**TYRONE TOWNSHIP  
REGULAR BOARD MEETING AGENDA  
DECEMBER 21, 2021 – 7:00 P.M.  
(810) 629-8631  
clerk@tyronetownship.us**

1. Lake Urban Crossings PUD Preliminary Site Plan.

**Subject: Agenda Request, Lake Urban Crossings Preliminary PUD Plan  
Recommendation for Approval**

## **Preliminary Site Plan/Planned Unit Development Review for Tyrone Township, Michigan**

PRELIMINARY OVERALL SITE PLAN LAYOUT FOR:  
**LAKE URBAN CROSSINGS P.U.D. CONDOMINIUM**  
PART OF SECTIONS 3 & 10, T4N-R6E,  
TYRONE TOWNSHIP, LIVINGSTON COUNTY, MICHIGAN

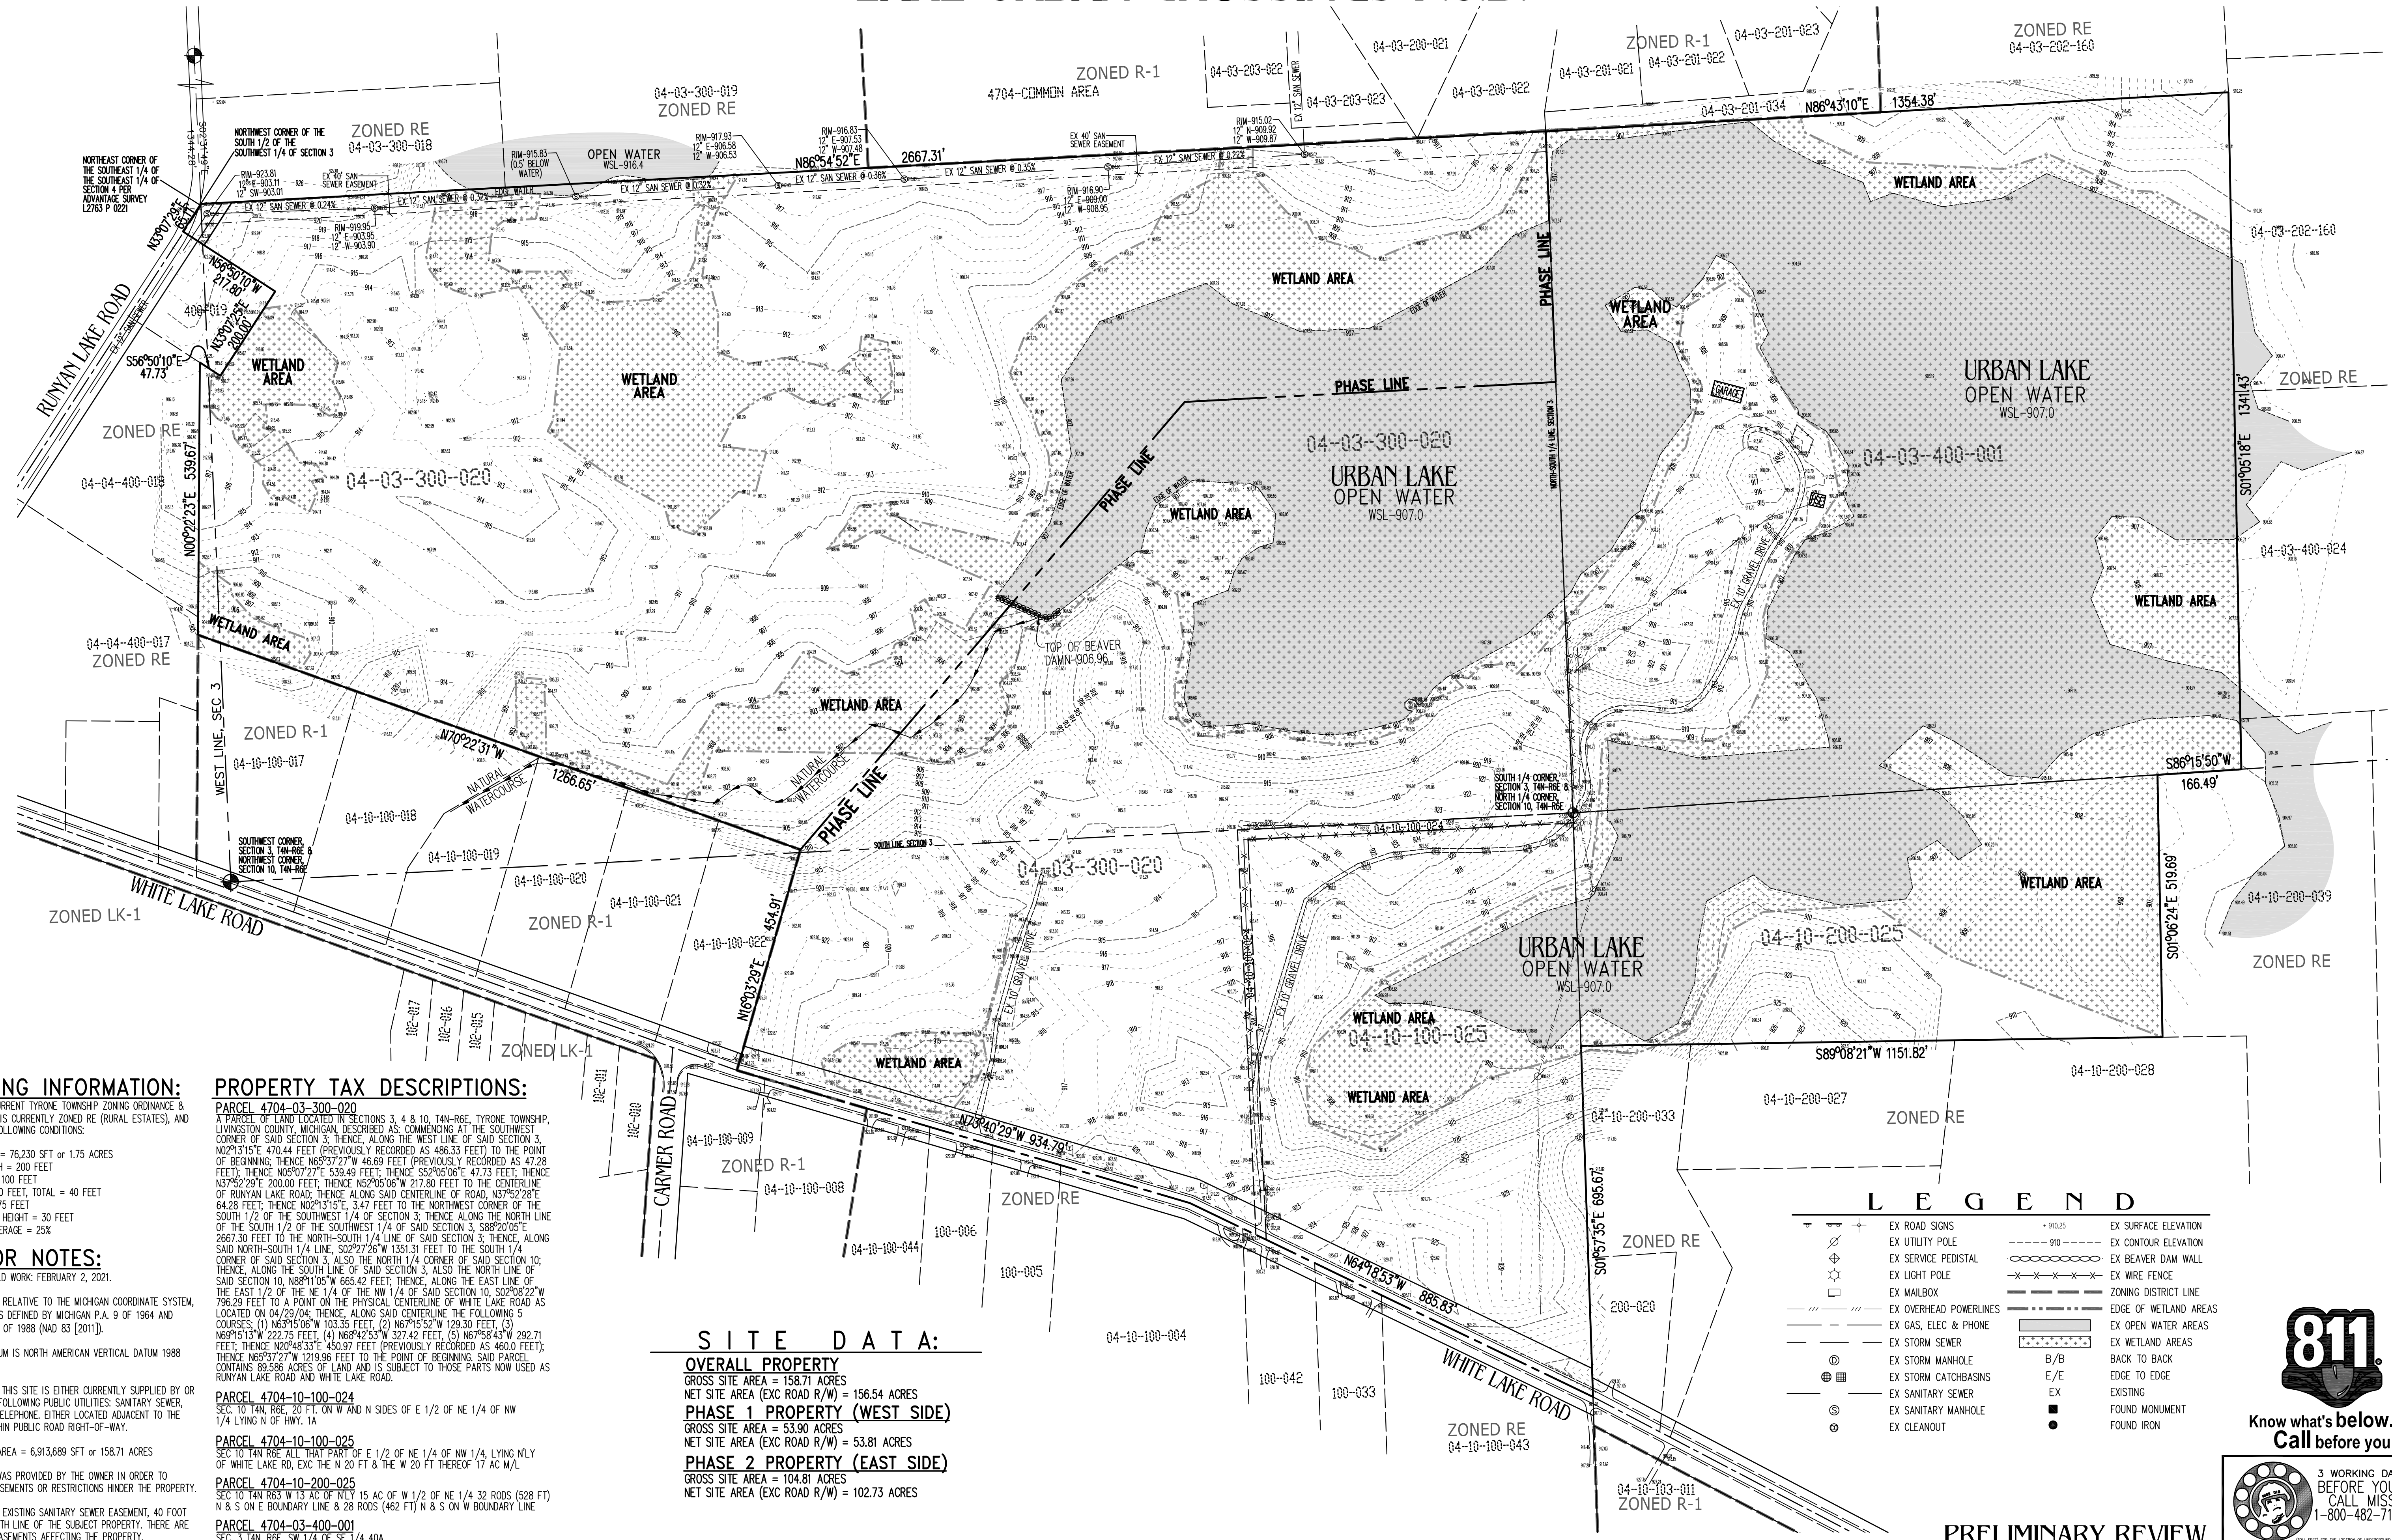
The Township may require street lighting for planned unit developments. At an earlier meeting, the applicant has stated they would be willing to install street lights and the location for street lights are shown on Sheet P-2.

# PRELIMINARY SITE OPEN SPACE PLAN LAKE URBAN CROSSINGS

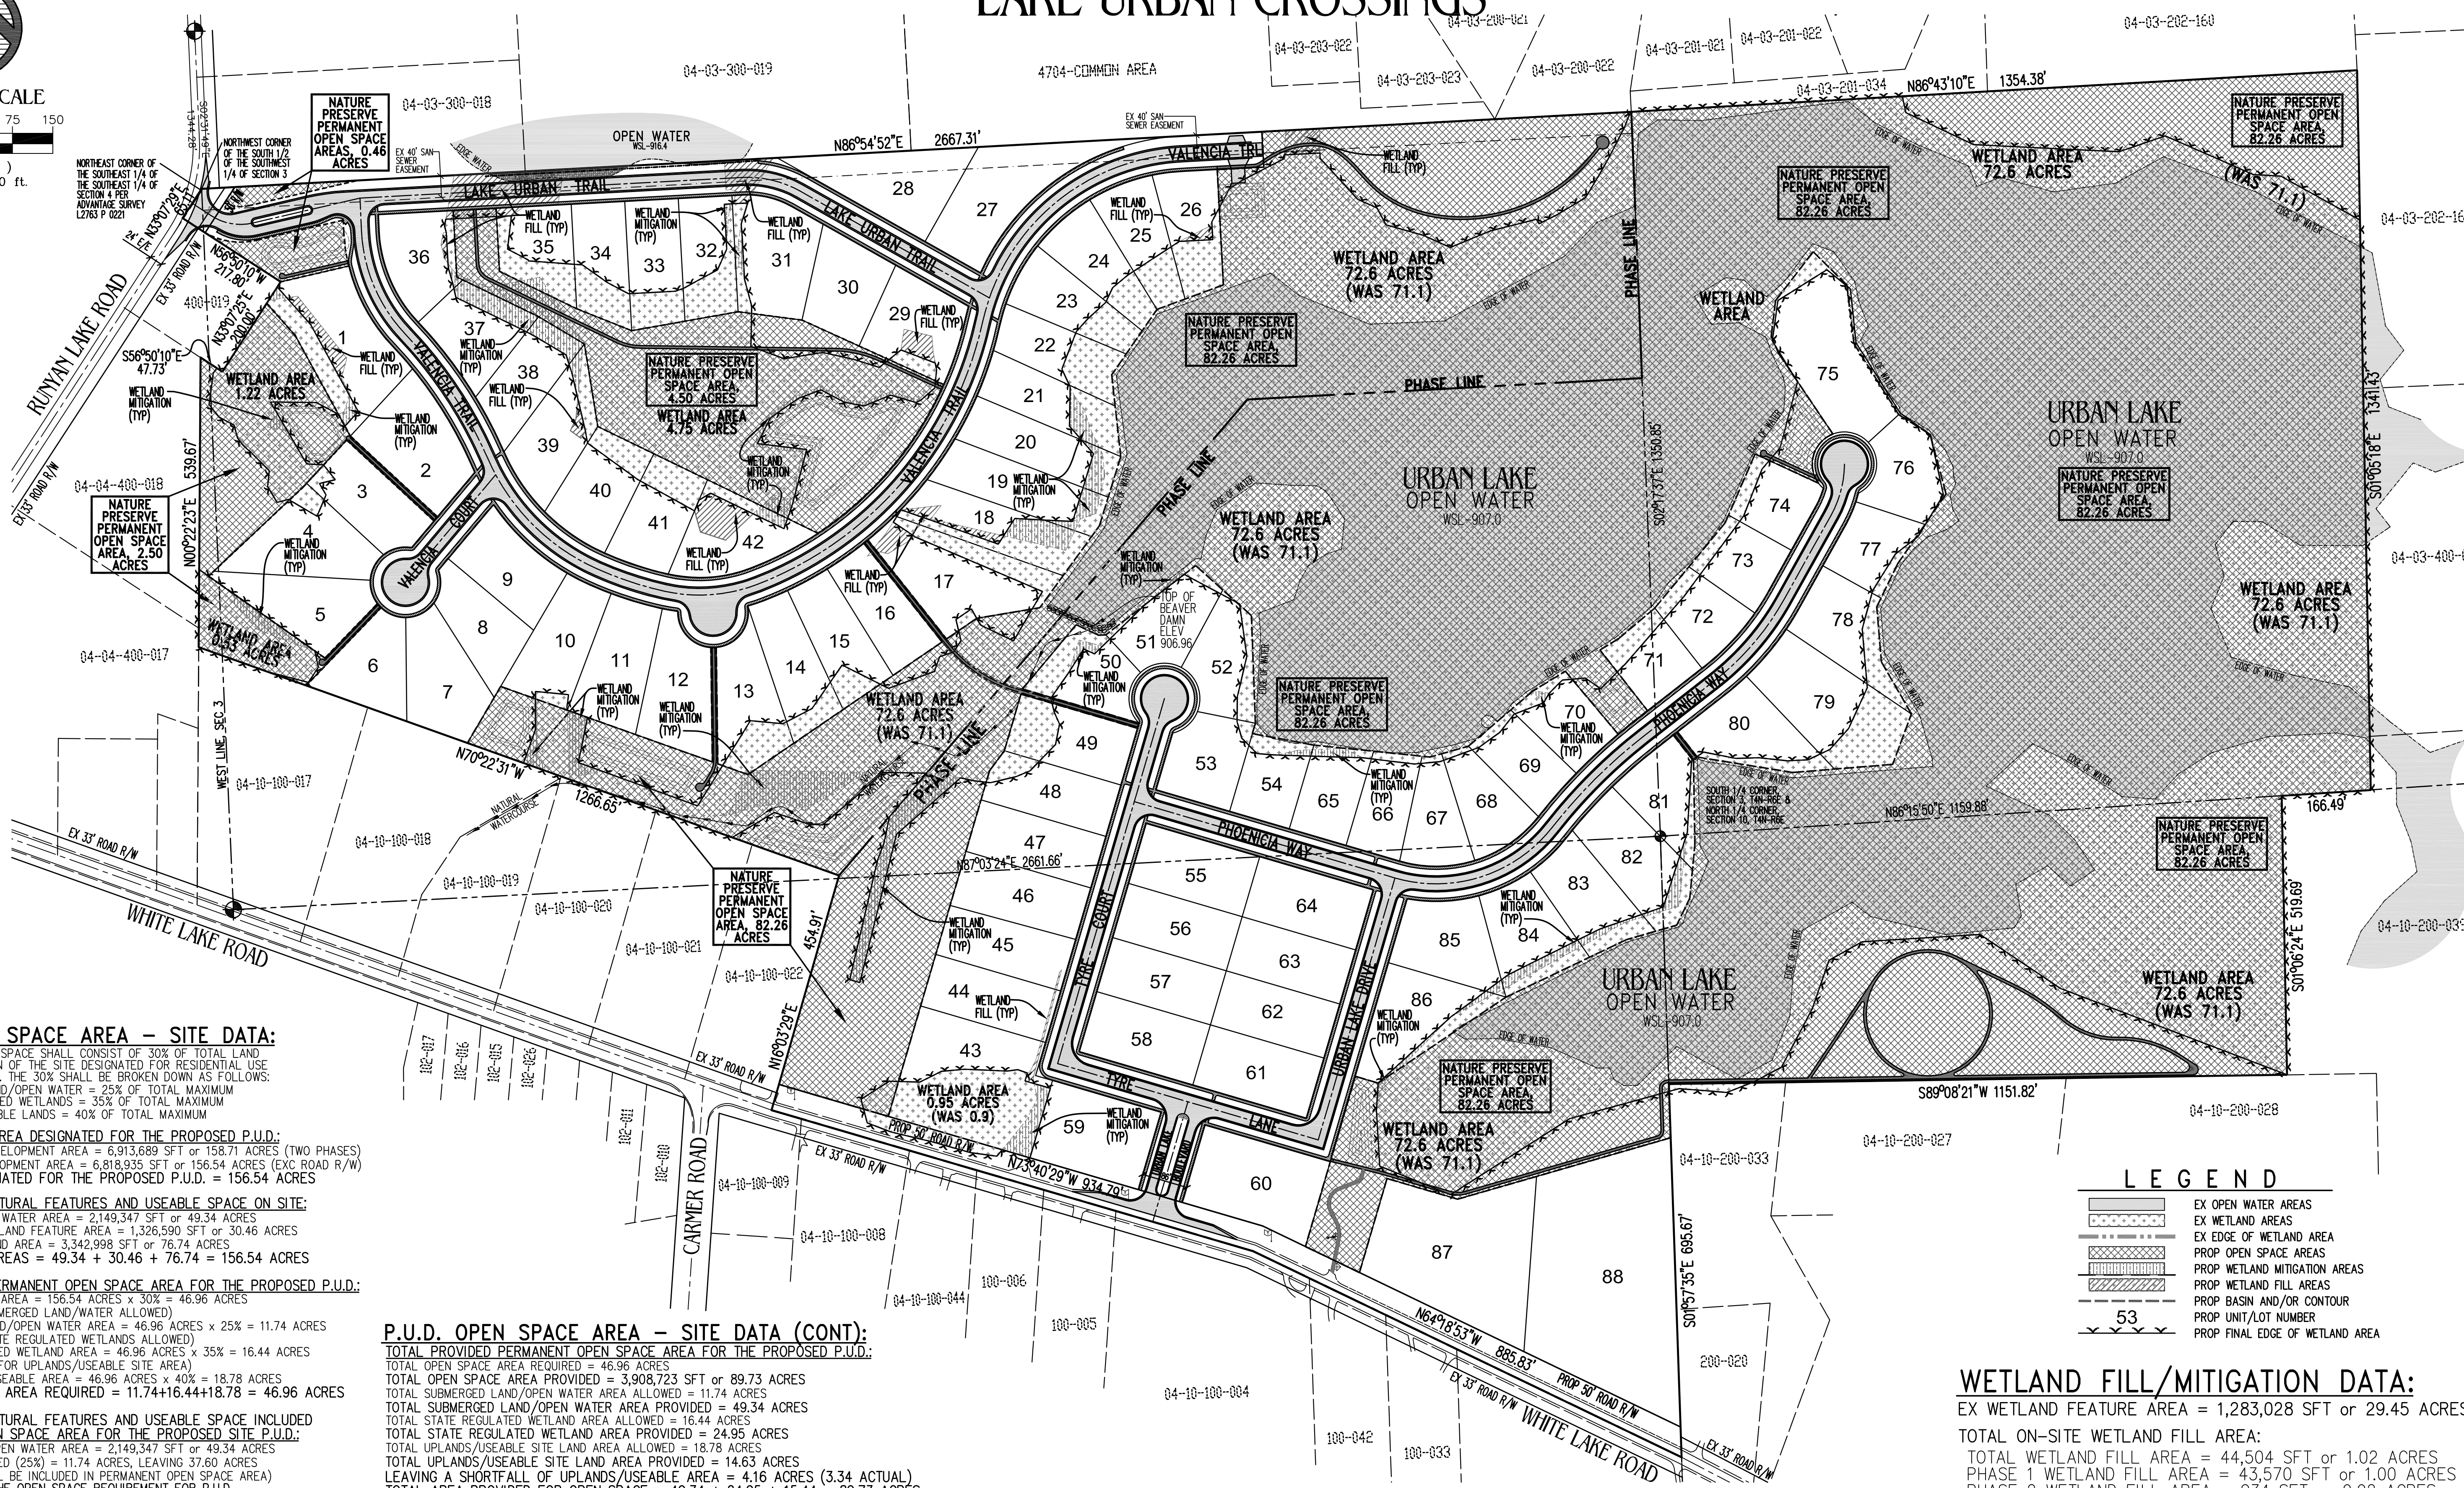
The calculations on Sheet P-5 states the open space would include 49.34 acres of submerged land/open water, 24.95 acres of state-regulated wetland, and 15.44 acres of upland. Based on the limitations above, the submerged lands and wetlands would be allowed to contribute a maximum of 28.17 acres. With the upland, a total of 43.61 acres of open space would be provided, according to the Zoning Ordinance, roughly 3.35 acres short of the required open space. (The calculations on Sheet P-5 incorrectly limit upland to 40% of the required open space, but there is no limit on upland contribution.)

9. *Open space calculations on Sheet P-5 should be corrected. (There is no maximum contribution of upland area and additional details about stormwater basins.)*

# PRELIMINARY SITE LANDSCAPING PLAN LAKE URBAN CROSSINGS

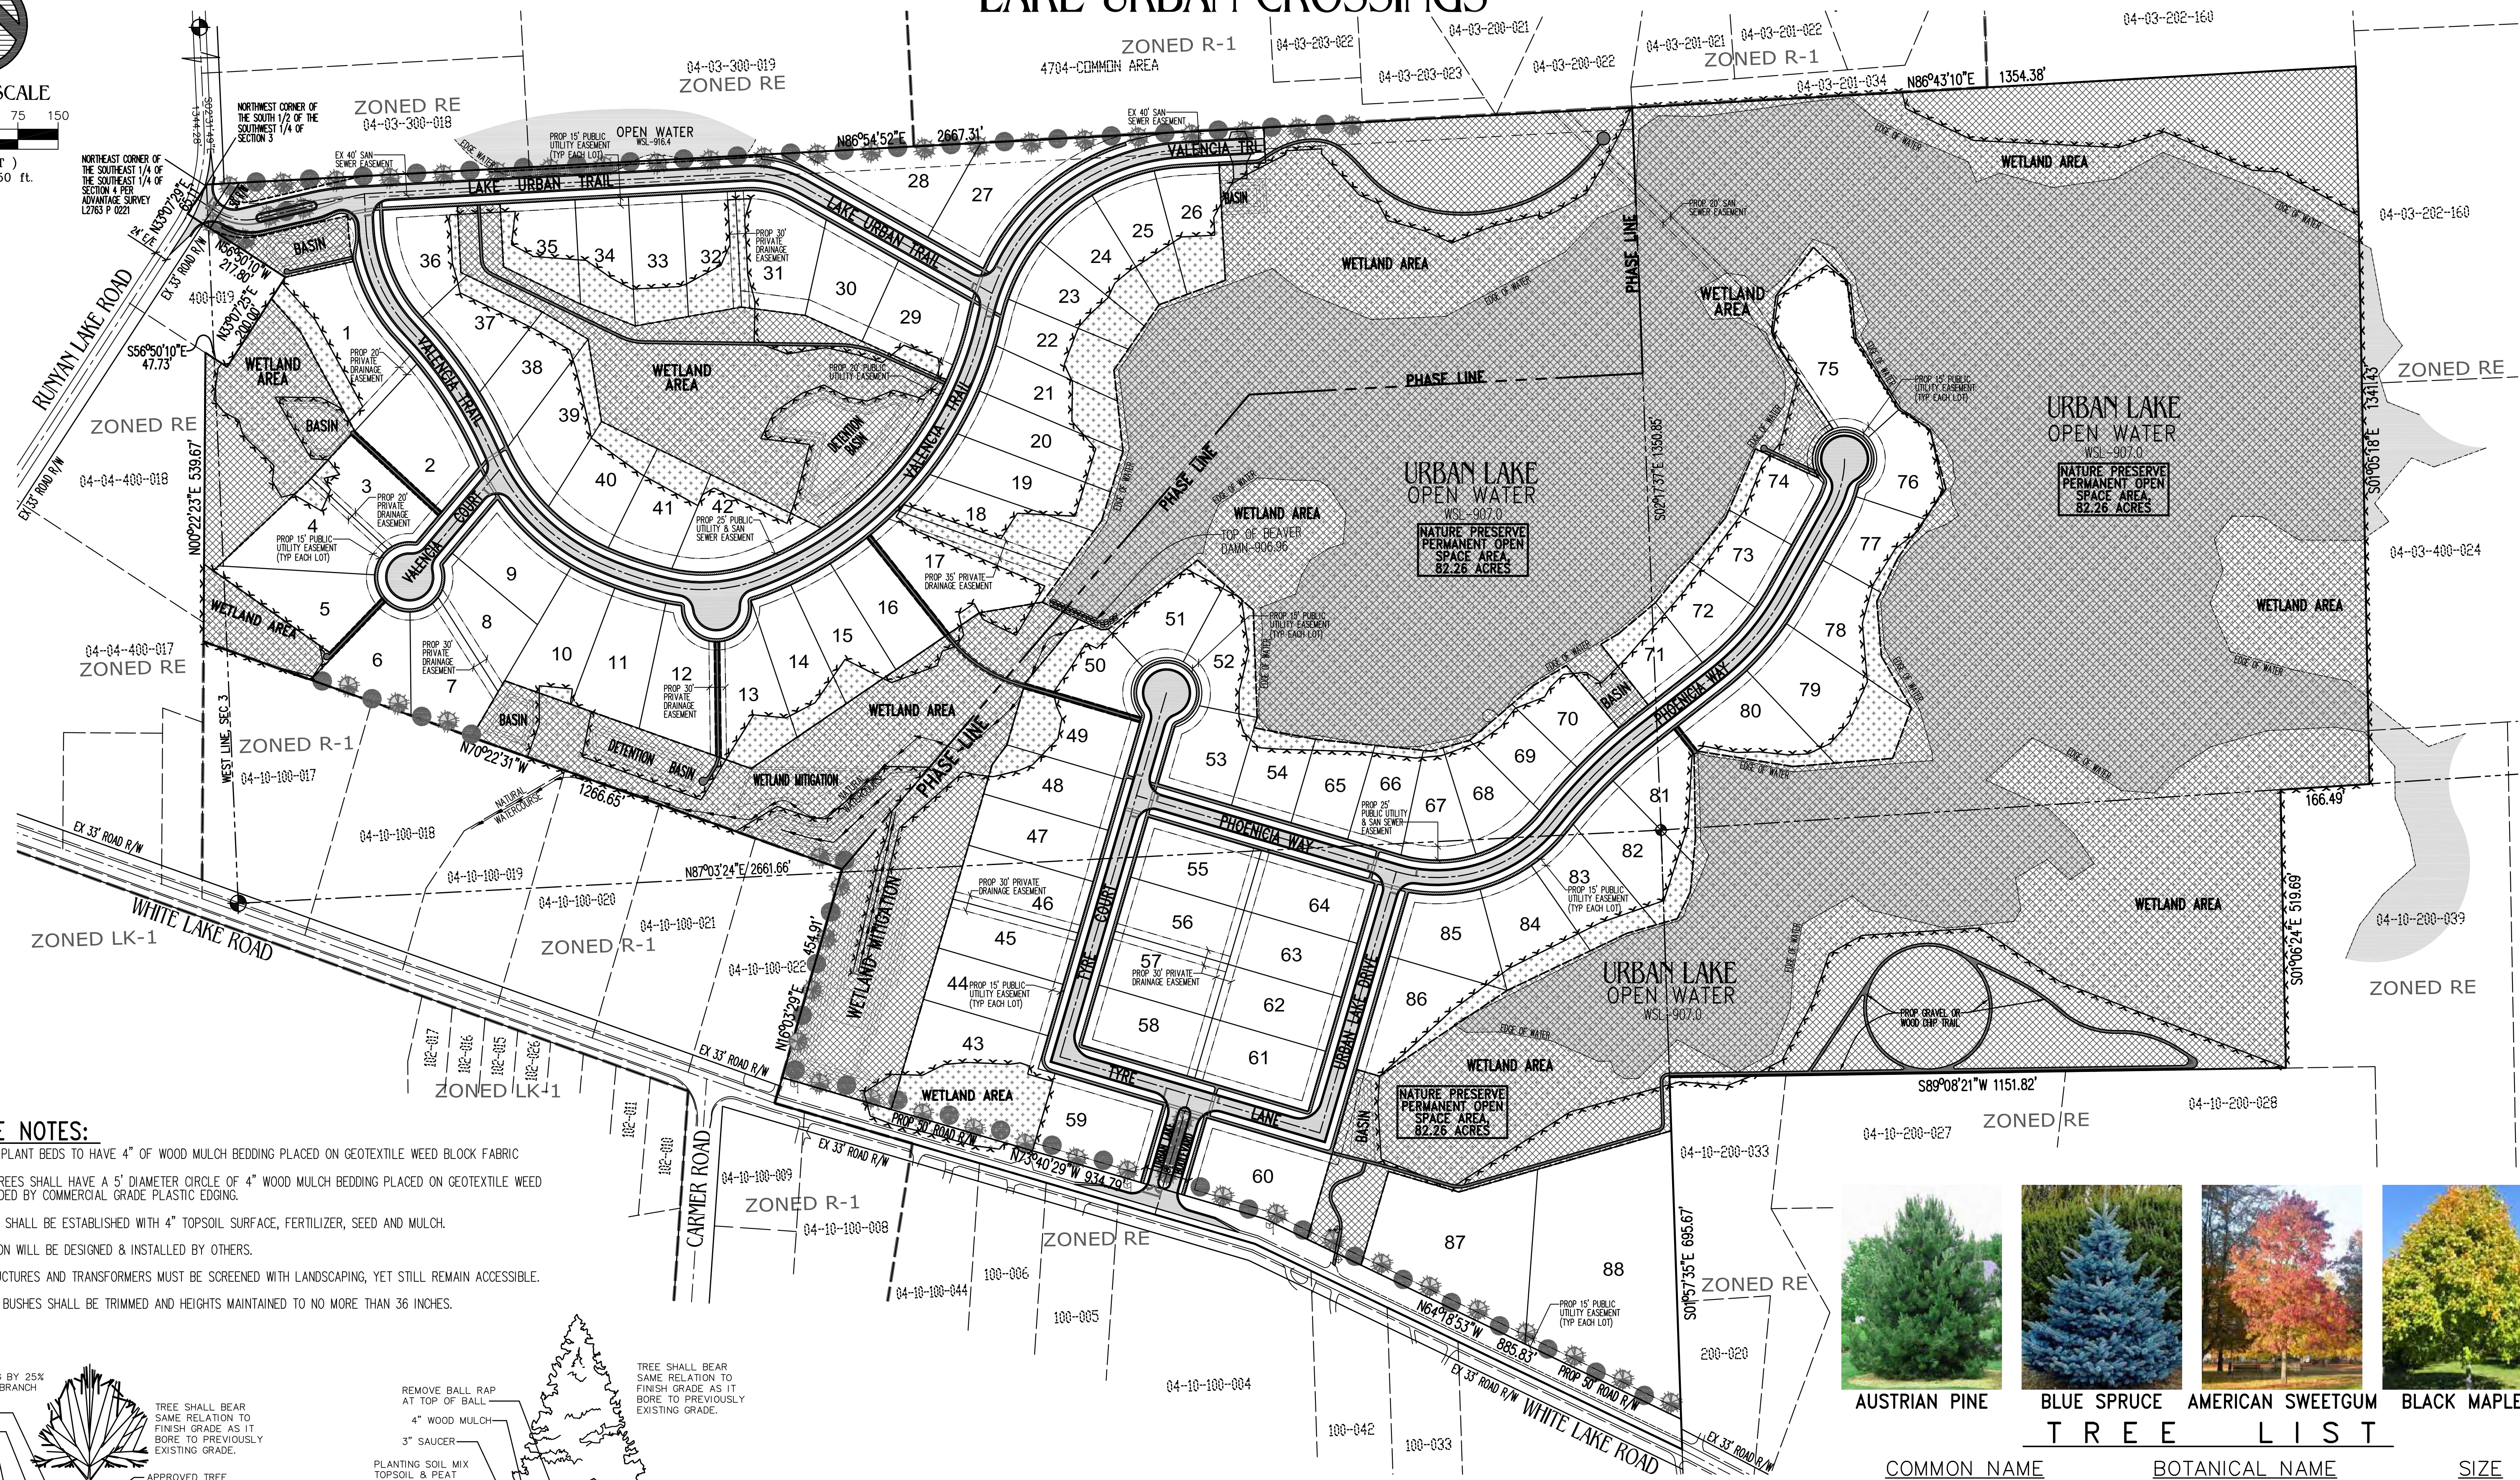
A landscaping plan is included on Sheet P-6.

**Comments:** *A landscaping plan has been submitted as Sheet P-6. It shows the rough location of proposed plantings and the types of trees to be planted.*
